**DELAWARE VETERANS MEMORIAL CEMETERY
MILLSBORO, DELAWARE**

DE-13-21

ADDENDUM NO. 1

June 21, 2016

LI103-SK-1
DELAWARE VETERANS MEMORIAL CEMETERY
 MILLSBORO, DELAWARE

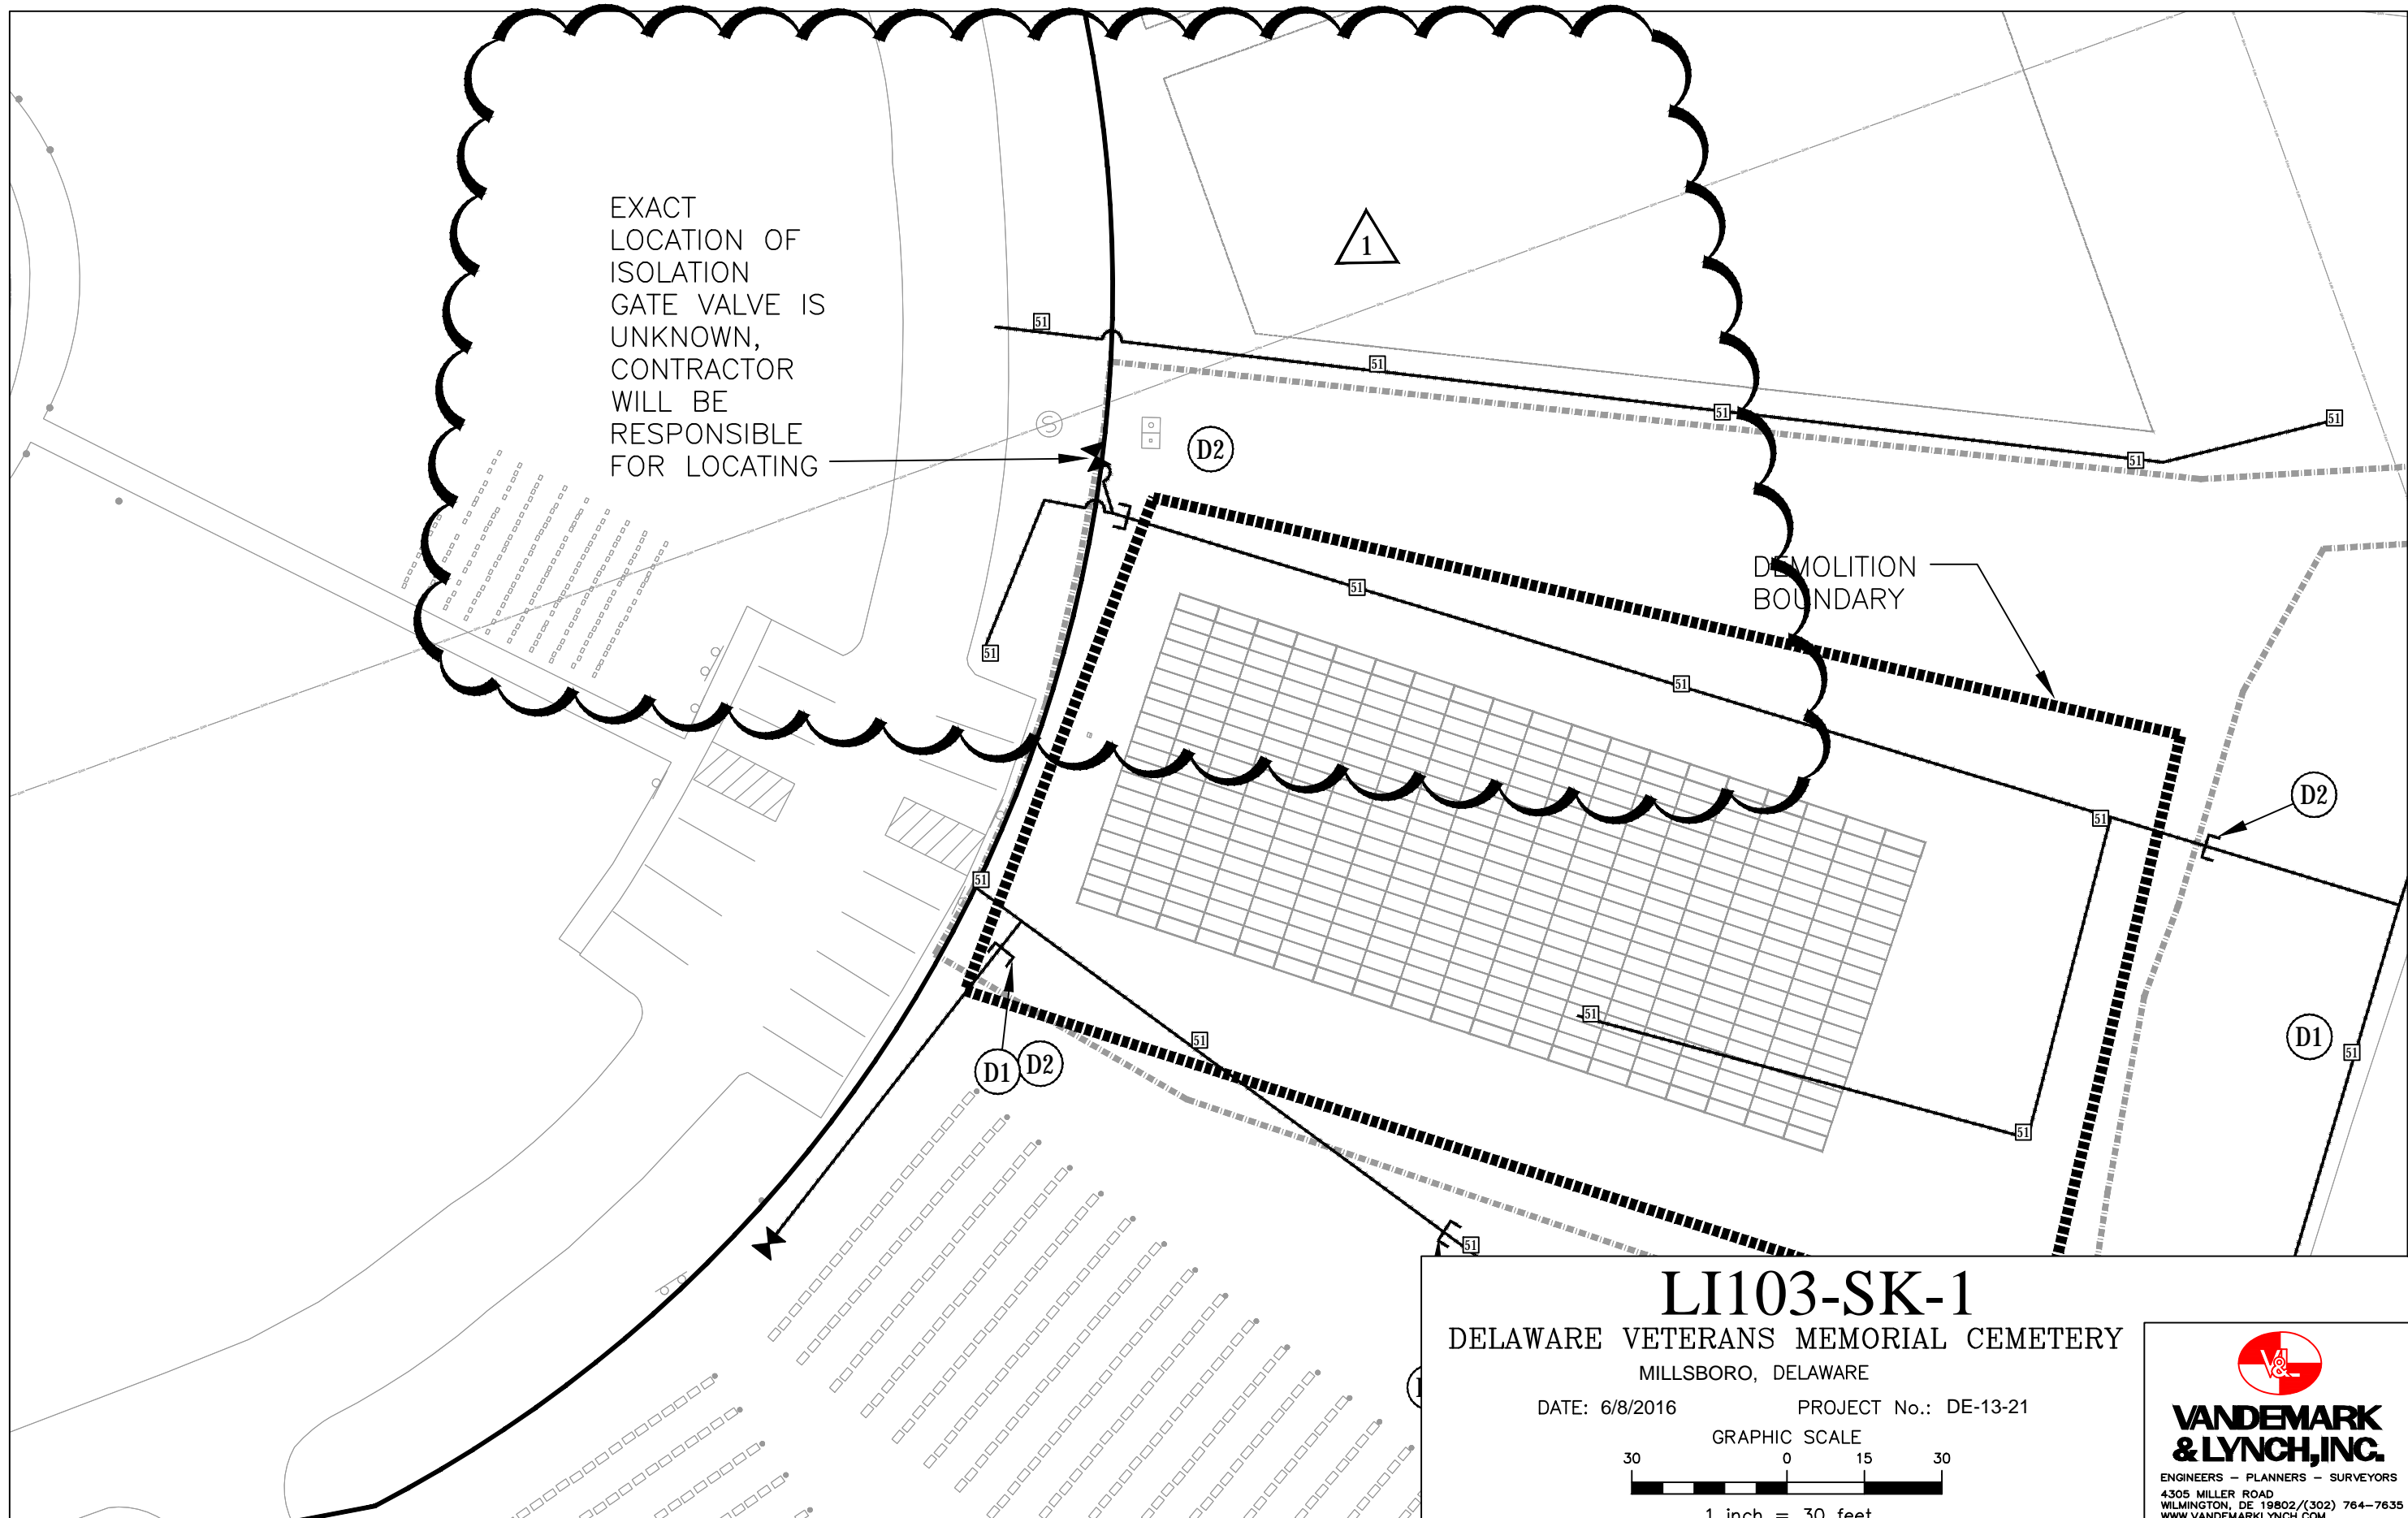
7. CU201-SK-1: Updated profile title to reference storm cleanout labels depicted in the profile.
8. LI103-SK-1: Added note requiring contractor to locate isolation gate valve.

LI103-SK-2

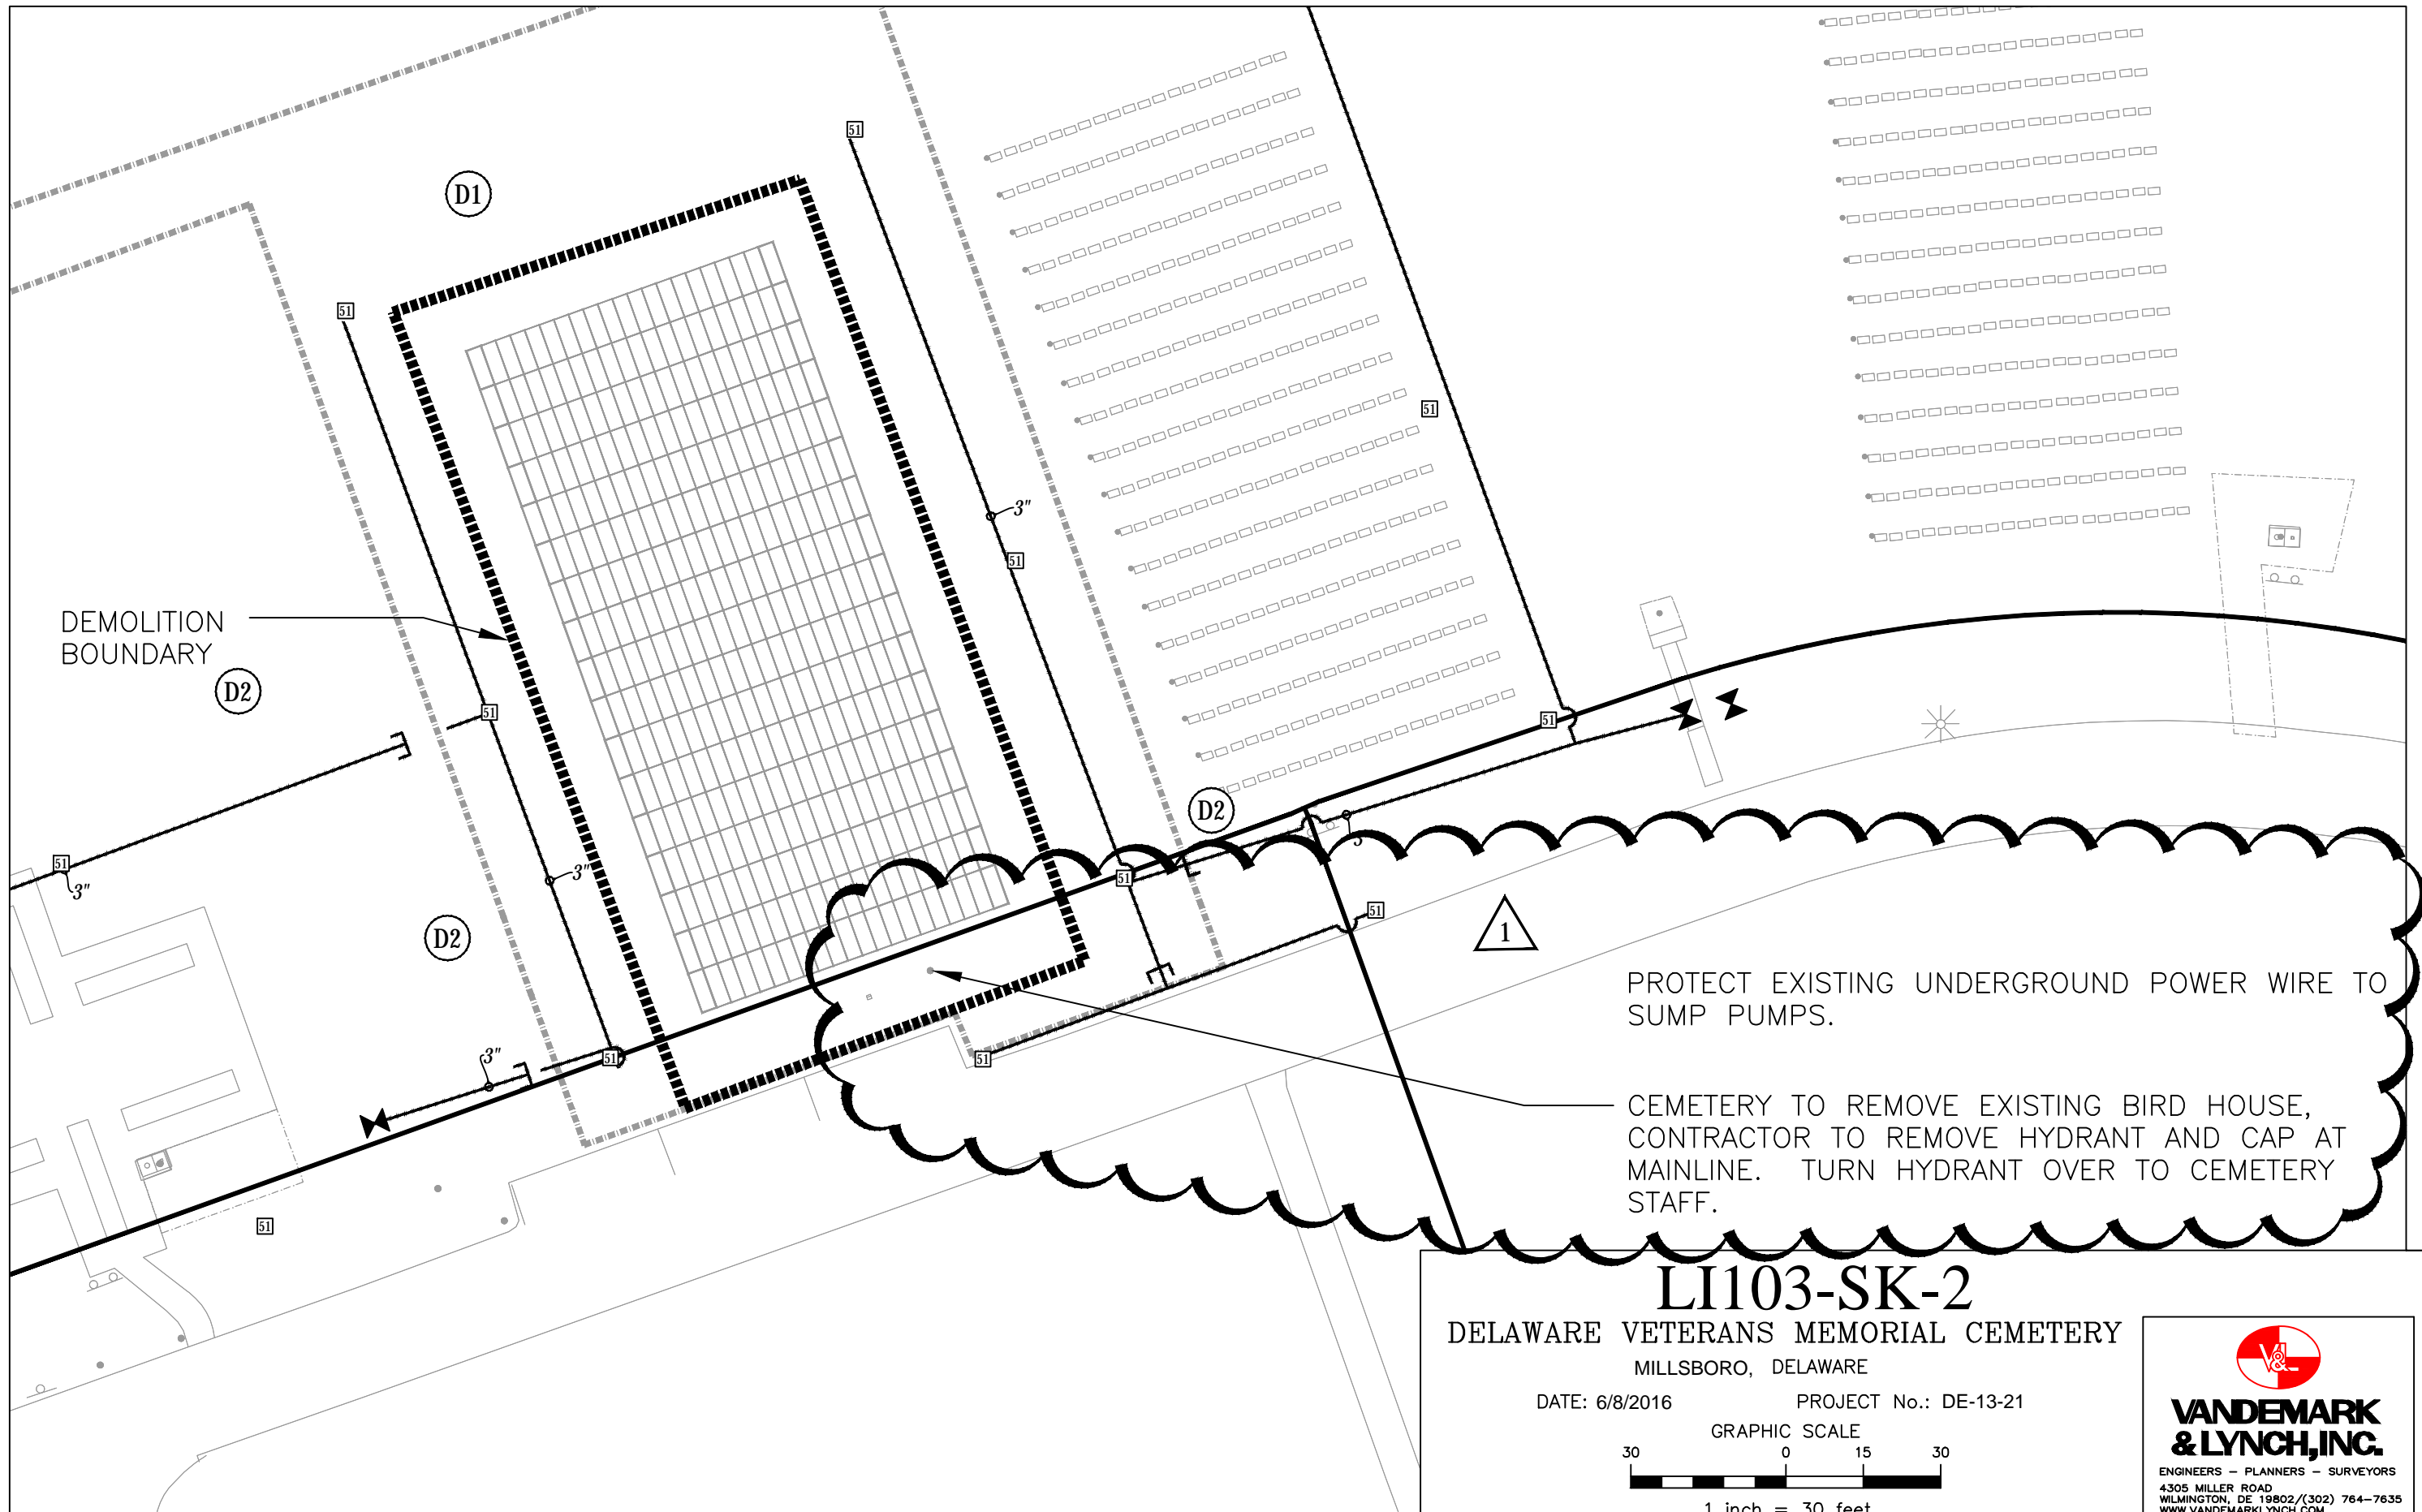
9. LI103-SK-2: Added notes requiring contractor to protect pumps power lines, remove hydrant and turn over to Cemetery staff. Note requires the cemetery to remove bird house.

- Note: Irrigation system discharge pressure is 90 PSI and the flow is 100 GPM on a 6” looped mainline, well water is utilized.
